### SUBDIVISION COMMITTEE REPORT

98034-(5) TBD

Revised Vesting Tentative Tract Map No.52584-1 Variance No. RVAR201300003 Conditional Use Permit No. RCUP201300081 Oak Tree Permit No. ROAK201300023 Environmental Assessment No. RENV201300138

### SUBDIVISION COMMITTEE REPORT RTR52584-1 06/09/16

· 169					
$Name_{\_}$	Nazem Said	Date	05-25-2016	Phone (	626)	458-4921
D·\ldnub\S	LIBBOHECK/Plan Chacking Files/Tract	Man\TD 52594\CD 5259	1\2015 12 10 TTD 52	OA CHIDMITT	\ I

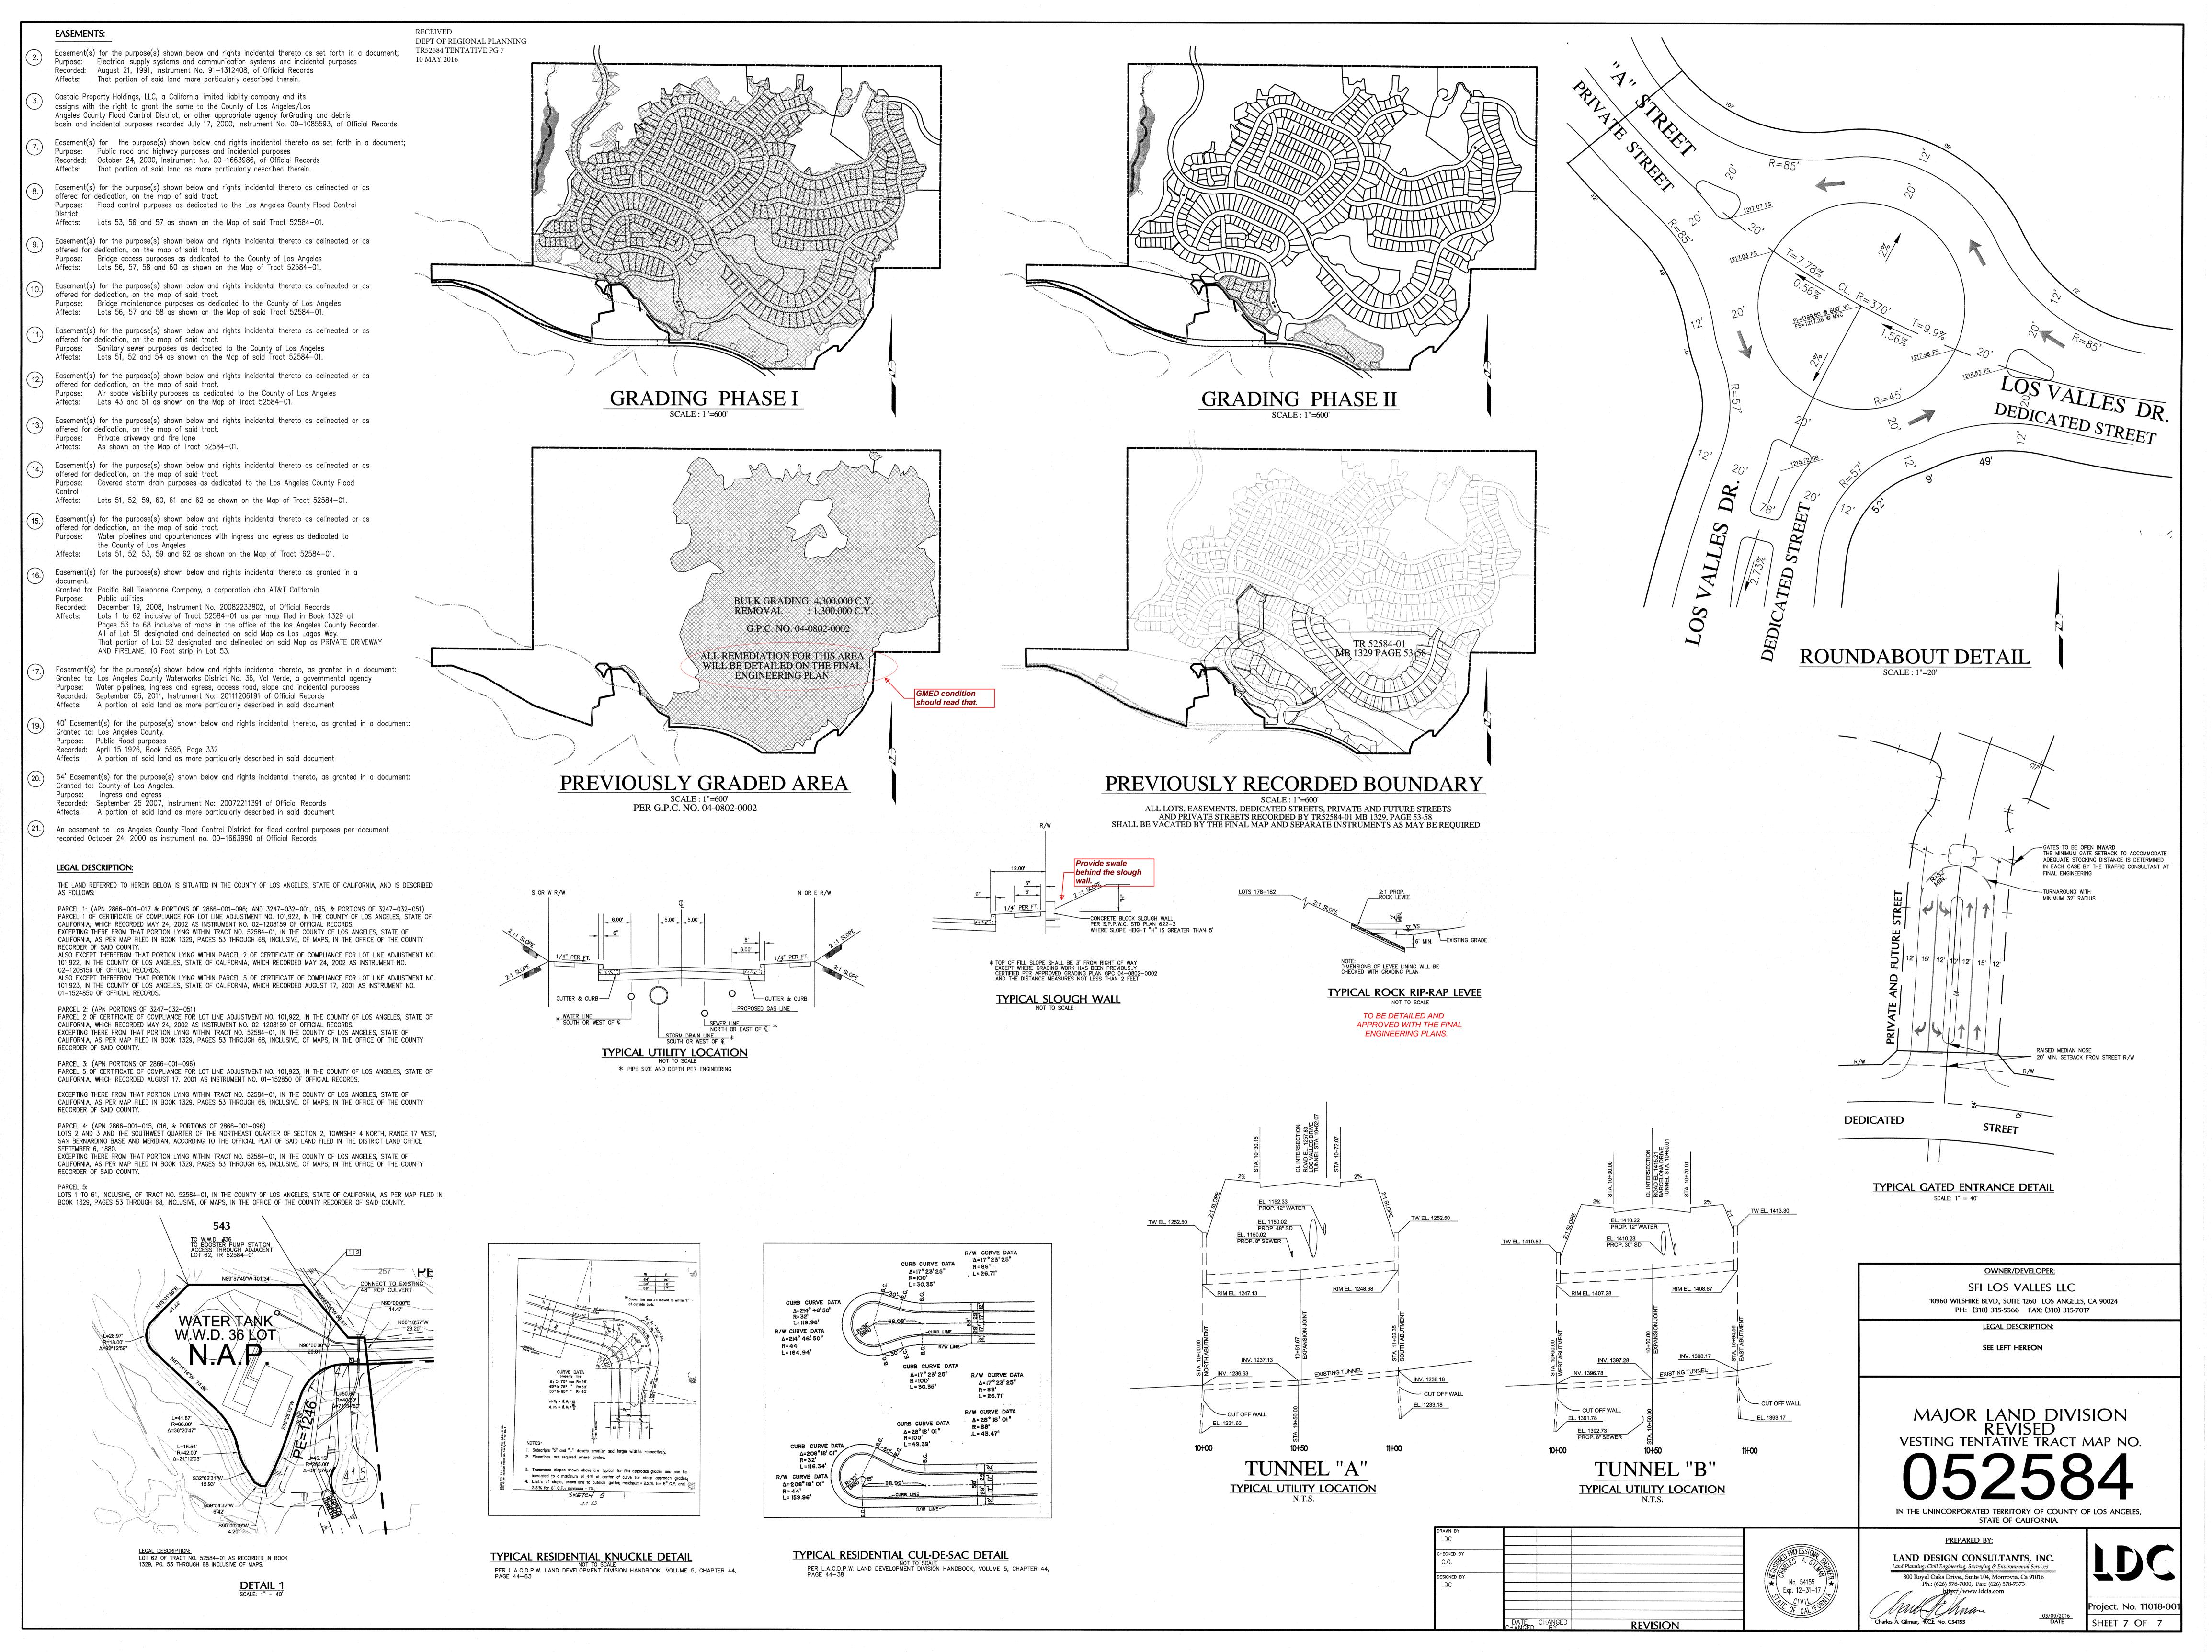
- 1. A revised tentative map and exhibit map is required to show the following additional items:
  - a. Earthwork volume, including cut, fill, import, and export, for all proposed improvement of this revised map. Also, show the volume for all graded areas. All volumes should be balanced with the volume on the previously approved tentative map or grading plans.

- b. Remove the "GRADING PHASE II" note shown on sheet 5 and conceptually show improvements that will be detailed on the final engineering plans. Hydromodification must be analyzed with hydrology prior to this map approval.

- c. Remove all proposed improvement shown inside FEMA boundary.
  - d. Provide a concrete swale with adequate drainage capacity behind the slough wall on detail on sheet 7.

- e. Rip-rap levee details shown on sheet 7 will be detailed on the final engineering plans.
- 2. Remediation note on sheet 7 must be included as a condition on GMED condition sheet and reflected on the grading conditions after GMED accepted it.

- 3. Additional comments on the map that was uploaded for your use at:
